Report to Planning and Environment Committee

Subject: 1170 Fanshawe Park Road East Inc. (c/o Brock Development Group Inc.)
1170 Fanshawe Park Road East
File Number: Z-9713, Ward 5
Public Participation Meeting

Date: April 30, 2024

Conceptual Site Plan

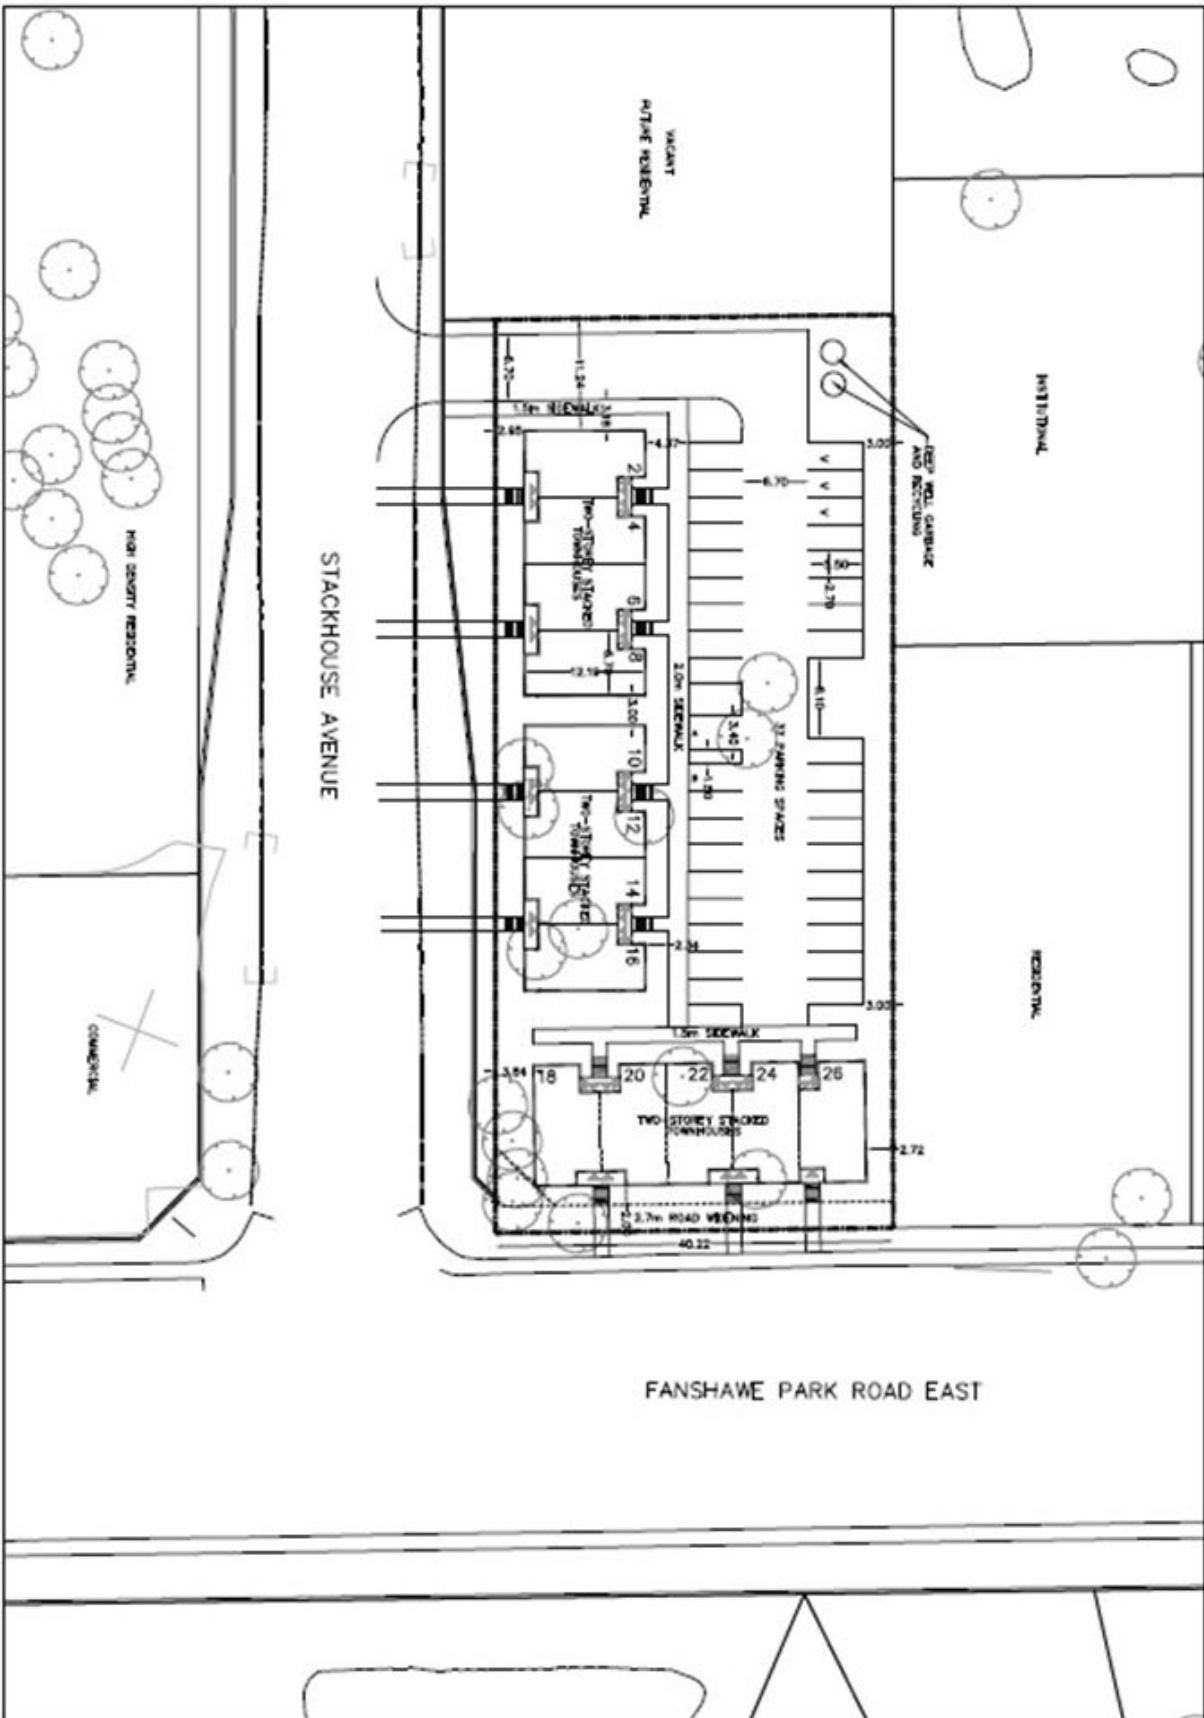
- Consider reducing the number of surface parking spaces provided in favour of an at-grade common outdoor amenity space and more landscaped area [TLP Policy 270, 295].
- Extend the 1.5m walkway proposed in front of Units 18-26 (Block C) to the street [TLP Policy 255, 268].
- Provide a public sidewalk or private walkway along the Stackhouse Avenue frontage and ensure the walkways proposed on-site connect to this sidewalk [TLP Policy 255, 268].
- Include facilities for temporary bicycle storage (bike racks) to promote active transportation [TLP Policy 280].
- Provide landscaping to mitigate headlight glare into the windows of the below-grade level.
- Provide a full set of dimensioned elevations for all sides of the proposed buildings with materials and colours labelled. Further comments may follow upon receipt of the elevations.

- Extend the sidewalk along the rear of units 18-26 to connect to Stackhouse Avenue.
- Enlarge all 1.5 metre sidewalks to be 1.8 metres for accessibility purposes. Refer to the Accessibility Checklist for more information.

- Ensure a 1.5 metre setback is provided between the rear property boundary and the drive-aisle to provide for landscape planting.
- Widen the 2.0 metre sidewalk running along the rear of units 2-16 to be at least 2.1 metres as this sidewalk is abutting a parking area.
